## US write-up of demonstration at 2nd meeting

- Drafted by NHTSA -

**Remark: The subsequent text does not contain the Meeting Minutes in the original version, but a summary of the discussions (Chapter 6) as perceived by NHTSA.**

Porsche 934

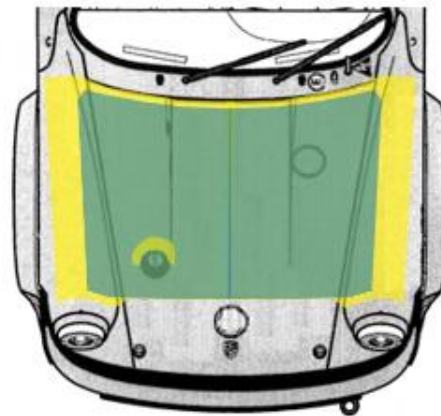
At the 2<sup>nd</sup> meeting of the technical sub-group on Amendment 3, Peter Martin (PM) demonstrated how NHTSA would conduct a compliance using a 1:12 scale vehicle model 1976 Porsche 934 as an example. PM noted that this car was identified by Oliver Zander (OZ) in an earlier meeting as one that has many contours that would be a good subject to assess the test protocol. For the sake of time, the SRL, WAD1000, WAD1700, BRRL, and 82.5 offset margins had been carefully "pre-drawn" on the vehicle the night before the meeting. During the meeting, a 2/3 HIC1000 border was hand drawn in real-time to demonstrate how a NHTSA lab would receive a "map" from the OEM (green area in pic above) and transfer it to the vehicle.

Afterwards, the compliance lab verifies that the ratio of the HIC1000 area provided by the OEM (and applied to the actual bonnet) to the area of the marked off bonnet top (which includes the 82.5 margins) is required to be at least 2/3. PM noted that the areas must be computed from the actual, marked off bonnet when viewed from above and in the X-Y plane (not the actual surface area). Finally, the 82.5 offsets are drawn. PM noted that GTR does not cover another contingency similar to the one noted by Benjamin Buenger (BB) earlier: that a portion of the HIC1000 may lie within the 82.5 margin
